**SAMPLING PLAN FOR REMOVAL ACTION
NUMBER 1 - REMOVAL OF CONTAMINATED
WATER UNDER FERNALD ENVIRONMENTAL
MANAGEMENT PROJECT BUILDINGS**

SEP 09 1993
DOE-2972-93

**SAMPLING PLAN FOR REMOVAL ACTION NUMBER 1 - REMOVAL OF CONTAMINATED WATER
UNDER FERNALD ENVIRONMENTAL MANAGEMENT PROJECT BUILDINGS**

FIGURE 1

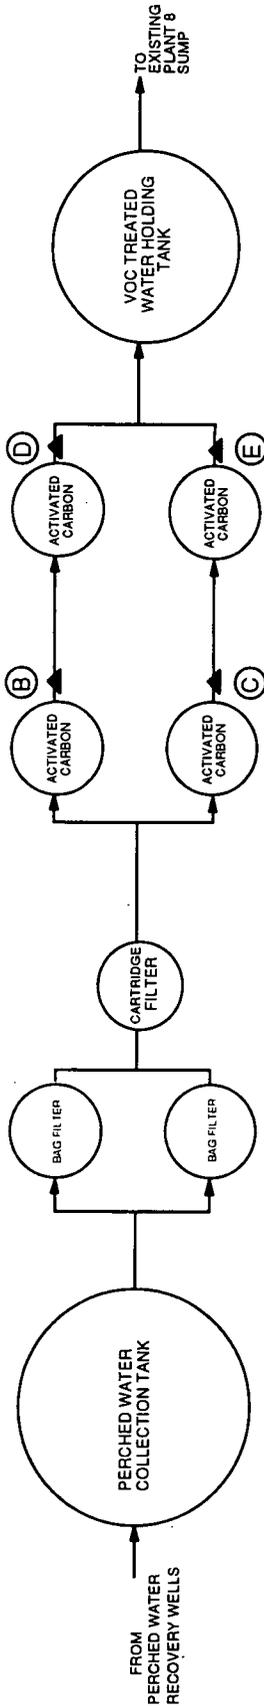
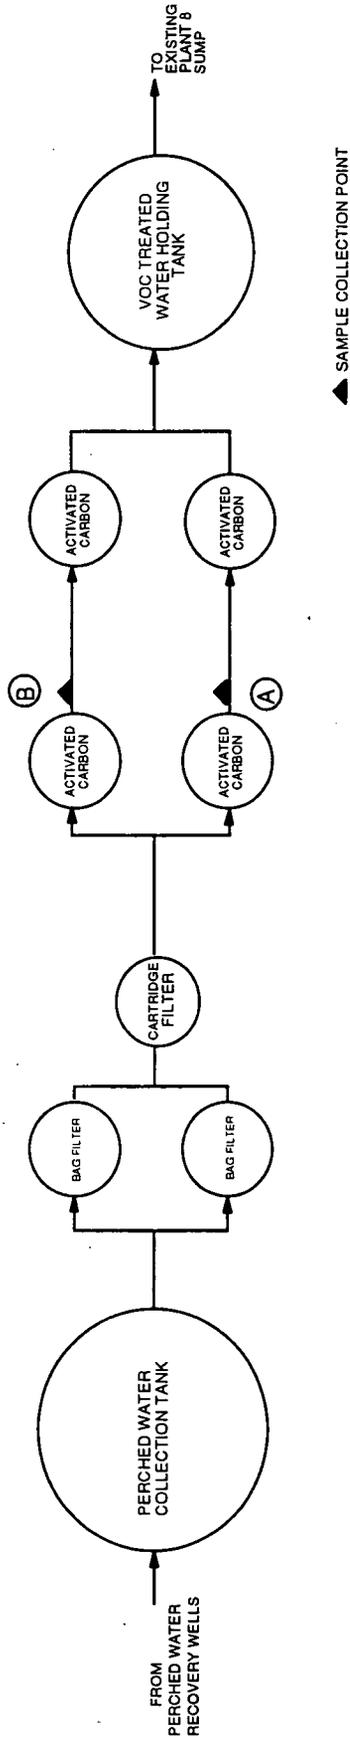
As a result of the above considerations, a further revision of the Removal Action 1 sampling plan is outlined below. This revision not only maintains the level of cost reduction realized by the previous sampling plan revision (Reference 1), but also continues to ensure system integrity and effectiveness. The enclosed Figures 1 and 2 illustrate the existing and revised sampling plans, respectively.

The primary (lead) carbon drum will be sampled once per week for Total VOA to detect breakthrough. Once breakthrough occurs, the secondary (lag) carbon drum will become the primary drum and a new replacement drum shall be installed as the secondary drum.

Sampling and analysis of the secondary drum effluent has been deleted. This is based on two items: 1) Utilization of the more comprehensive VOA analysis rather than POX, and 2) the demonstrated effectiveness of the lead drum in complete VOC removal.

Monthly uranium analysis at each extraction well will continue to determine well-specific uranium removal. Annual sampling at each extraction well will continue to assess the long-term effect of the extraction pumping.

SAMPLE POINT 1	ANALYSES	FREQUENCY	RATIONALE
B & C	Purgeable* Organic Halides	Every Batch 2	Breakthrough of Activated Carbon 3
D & E	Total Volatile Organic Analytes	Once per month	Verify integrity of system
Extraction Wells	Full HSL Total Radiological Parameters	Annually	Pumping Effectiveness
	Total Uranium	Once per month	Uranium Removal

NOTES: 1) Current sample points A and F will be eliminated.

3) At the time purgeable halide analyses indicates breakthrough, the secondary drum will be moved to the primary position and a new drum will be placed in the secondary.

SAMPLE POINT	ANALYSES	FREQUENCY	RATIONALE
A & B	Total Volatile Organic Analytes	Once per week	Breakthrough of Activated Carbon
Extraction Wells	Full HSL	Annually (Once per year)	Pumping Effectiveness
	Total Radiological Parameters		
	Total Uranium	Once per month	Uranium Removal
